CERTIFICATE OF APPROPRIATENESS

Property: 1405 Arlington Street, Lot 12, Block 159, Houston Heights Subdivision. The property includes a new 3,227 square foot, two-story single family residence and a detached one-story garage situated on a 6,600 square foot (50' x 100') corner lot.

Proposal: New Construction – The applicant was approved for a new two-story single-family residence at the March 2013 HAHC meeting. In March the approved residence measured 36'-5" wide, 68'-9" deep, built on a 2' slab foundation with an eave height of 23'-7" and a ridge height of 33'-7".

HAHC Action: Denied

EAST ELEVATION – FRONT FACING ARLINGTON STREET
EXISTING/PROPOSED

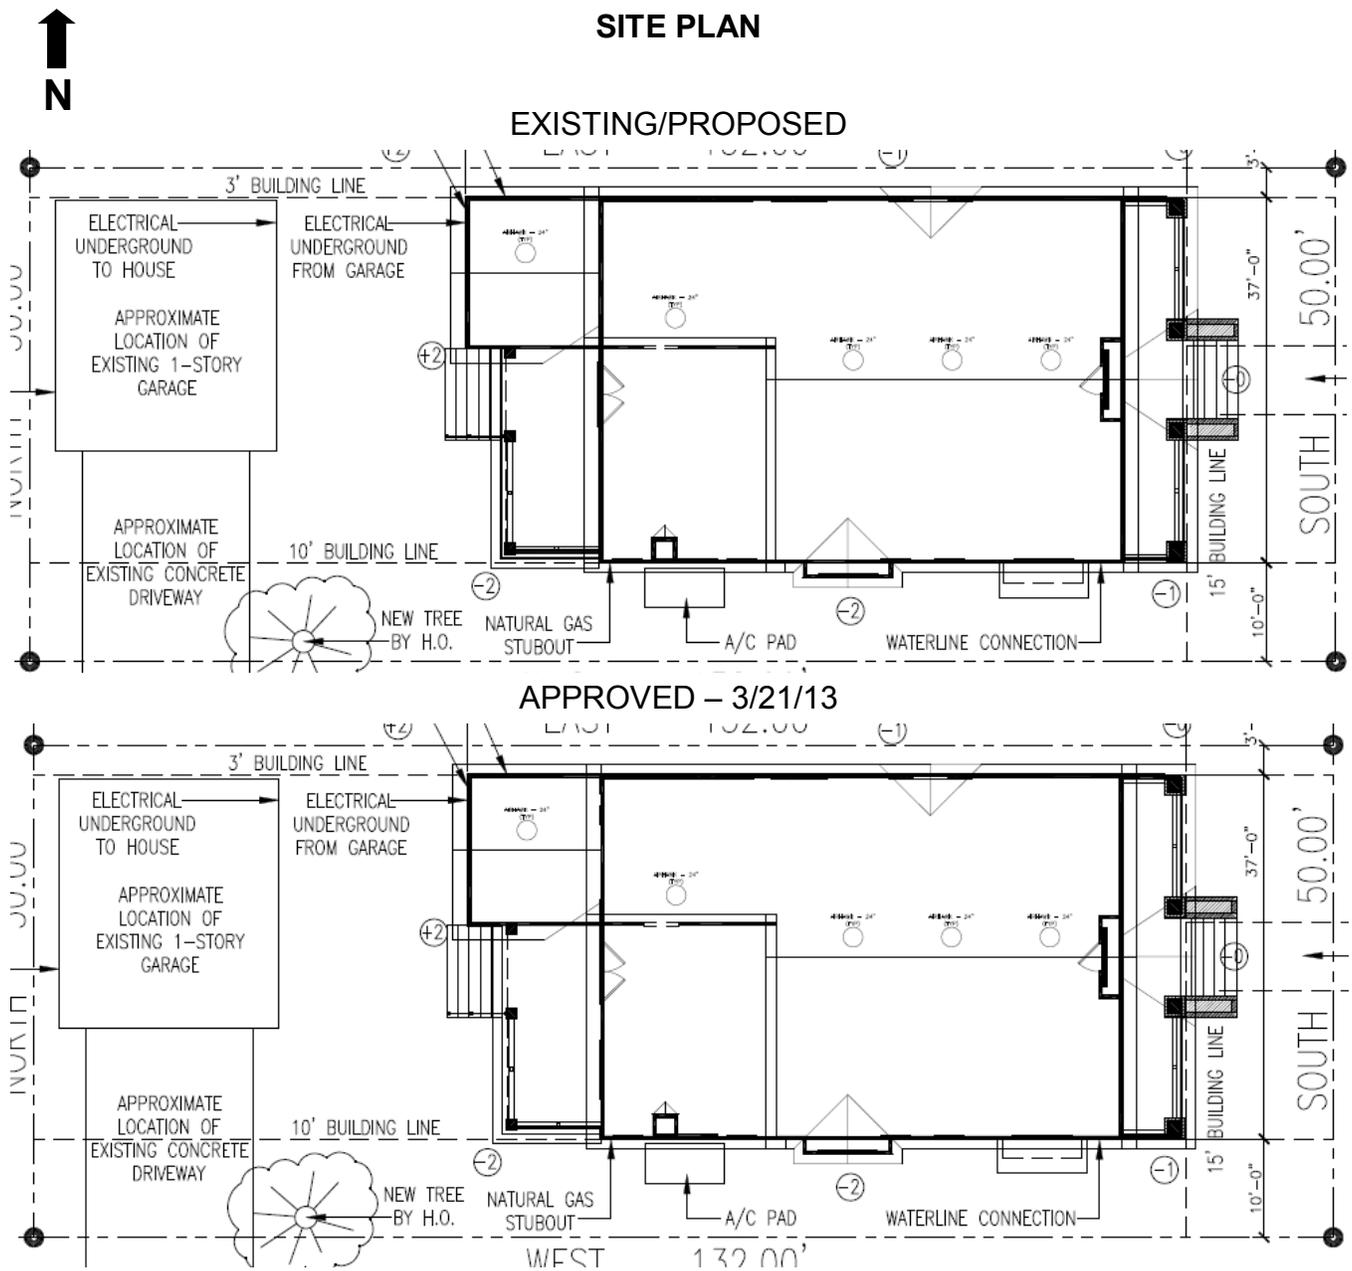
- Retain the existing flange mounted vinyl windows with interior muntins or re-glaze the top sash.
- Retain two existing 6-over-1sash windows with transoms on the south elevation; March 2013 condition stated not transoms to be installed on the south elevation.
- Change proposed 2' slab foundation to a 44" pier and beam foundation
- Increase in eave height from 23'-7" to 26'
- Increase ridge height from 33'-7" to 36'

- **Measured foundation height at 44"- Increase in 20" approved at 24"**
- **Measured front porch columns- 25" base approved plans show 18" base**
- **Two windows on south elevation do not meet condition and feature three transom. All windows are flange mounted vinyl sash windows with interior muntins.**

- **Foundation height: 41"**
- **Eave height: 26'**
- **Ridge height: 36'**
